## PLAN COMMISSION

March 26, 2019

**DRAFT MINUTES OF THE  
OAK CREEK PLAN COMMISSION MEETING  
TUESDAY, MARCH 12, 2019**

Proposal: Plan Review – Exterior Building Modifications

North Elevation

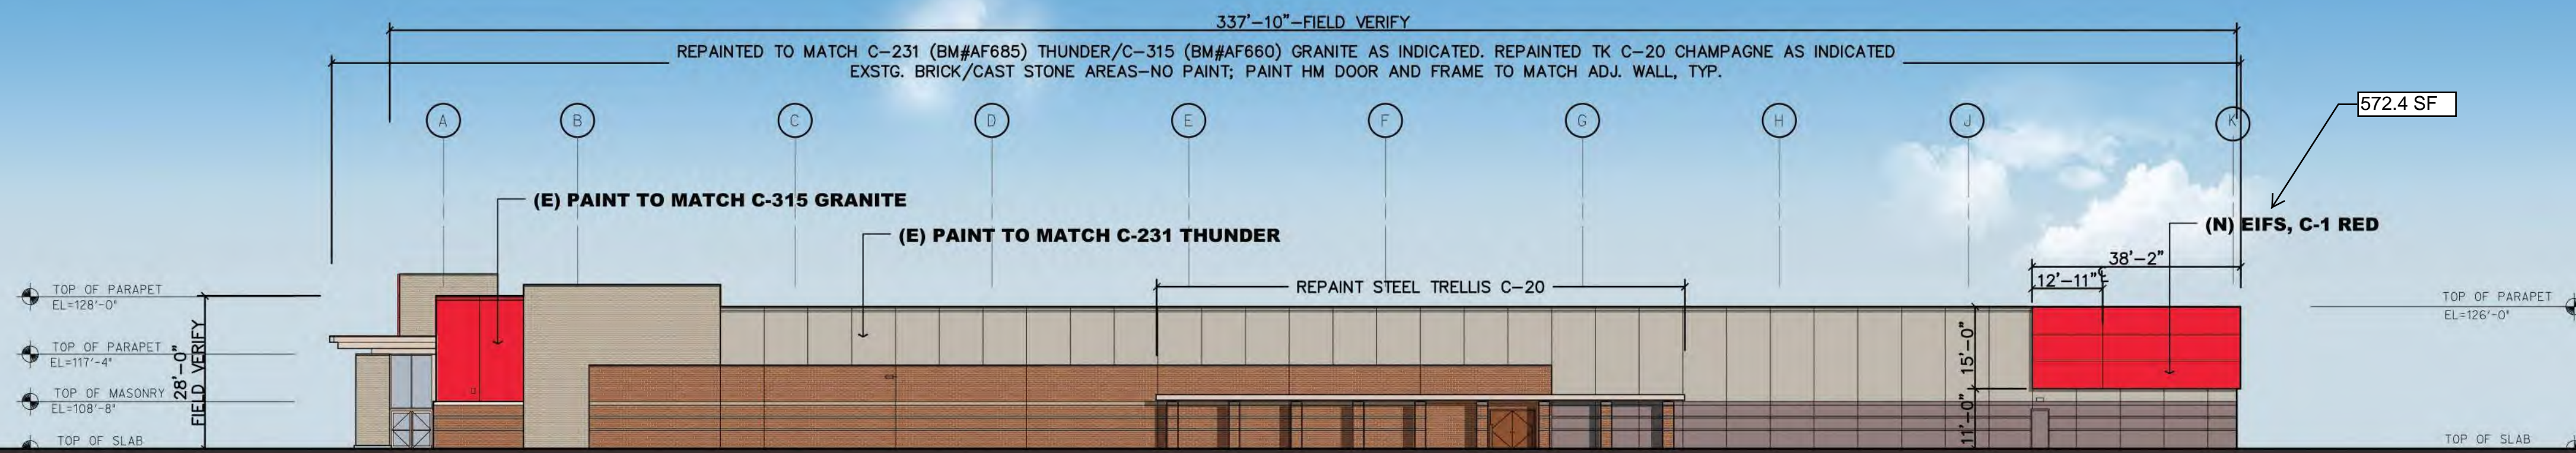
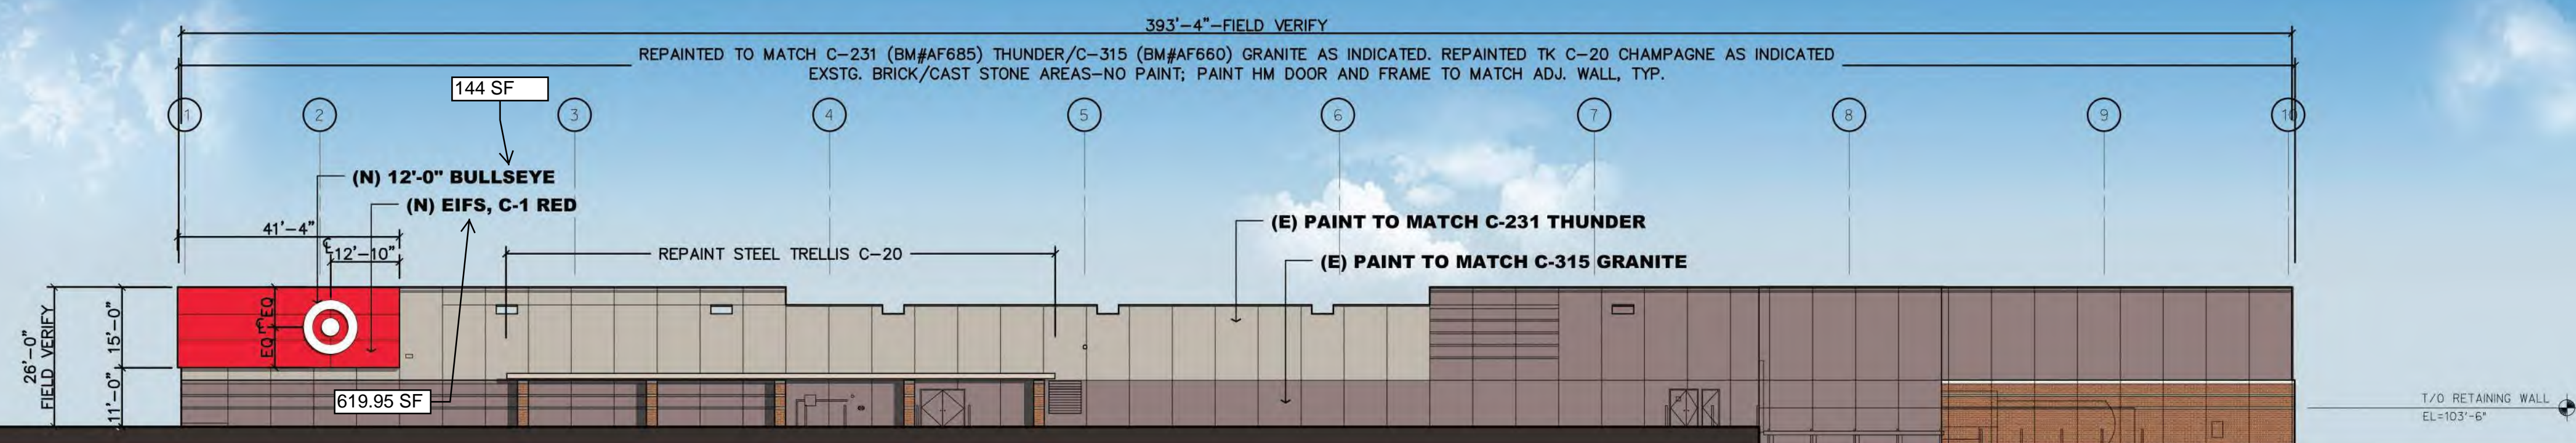
As stated in the submitted narrative, the north elevation will include 572.4 square feet of EIFS panel, and the west elevation will include 619.95 square feet of EIFS panel. Since the north elevation is approximately 9,300 square feet, and the west elevation is approximately 10,200 square feet, the EIFS is well below the maximum 25% allowed. Therefore, staff has no objection to the proposed modifications.
